# PERMIT

SEWAGE DISPOSAL SYSTEM  
HOWARD COUNTY HEALTH DEPARTMENT  
BUREAU OF ENVIRONMENTAL HEALTH  
410-313-2640

SUBDIVISION Eyre View LOT NUMBER 10 ADDRESS 16091 A. E. Mullinix Road

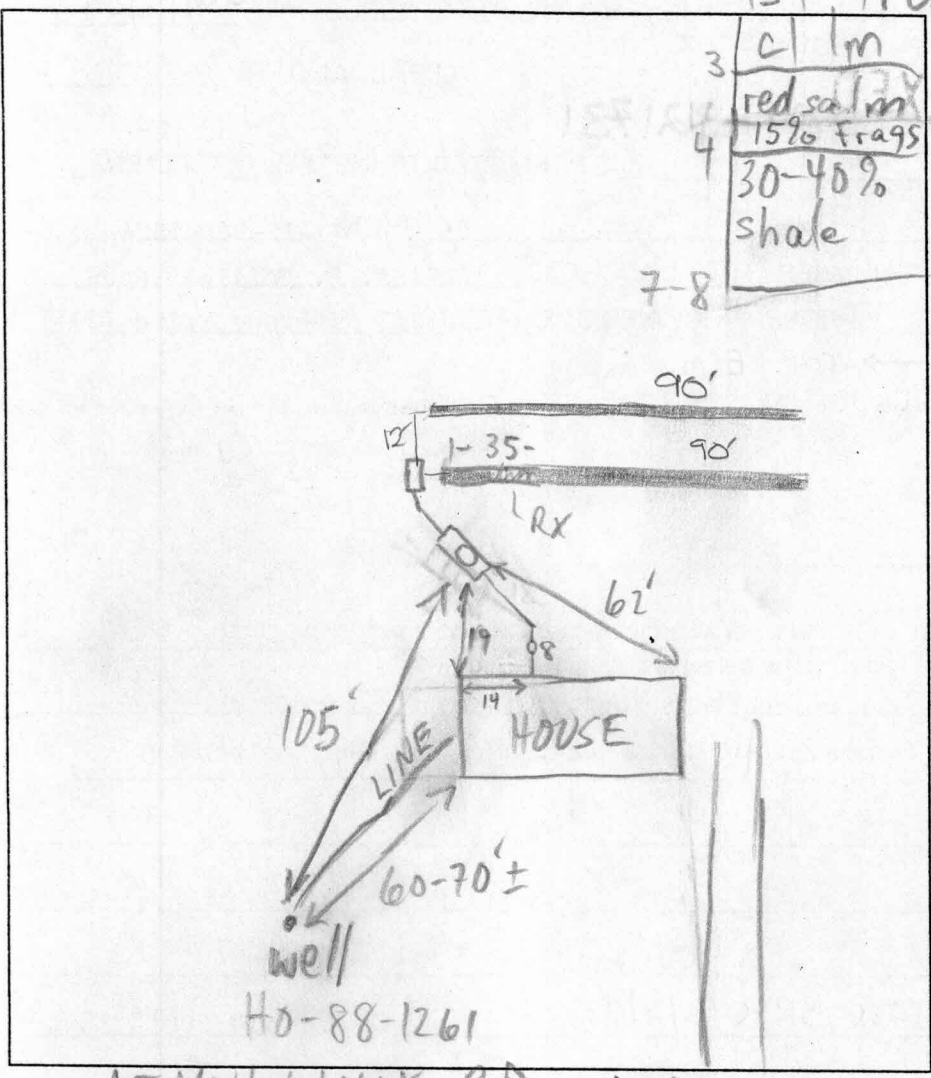
1st trench

3	cl lm
4	red sa lm
	15% frags
7-8	30-40% shale

INSPECTION COMMENTS: 5/7/01 1ST TRENCH EXCESSIVE RX, SPECS  
MODIFIED TO SHALLOW SYS (MR)  
5/8/01 FINAL INSP - OK TO COVER ALL SEPTIC WORK. DCC

35' FIRST TRENCH @ ORIG SPECS, 45' ADD'L w/SHALLOW DESIGN ABOVE  
2ND TRENCH 90' w/SHALLOW DESIGN ABOVE (MR)
